Hi-Fi Products
Service Bulletin

Model: CDP-C201/C205/C215/C225/C27/C305/C315/
C322M/C35/C37/C400/C401/C500/C515/C700/
C705/C715/C75ES/C8ESD/C800/C85ES,
SEN-301CD/311CD/501

No. 244R1

Subject: Part Change: Disc Table

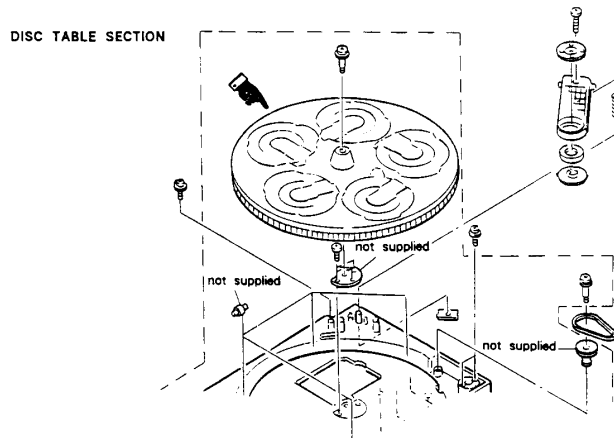
Symptom: (**)
Disc tables supplied by KCP for replacement will be of the 2-hole type instead of the 1-hole type on some models.

Solution: Order the disc table having the desired finish from the chart below. The 2-hole type disc table replaces the 1-hole, 1-slot type disc table.
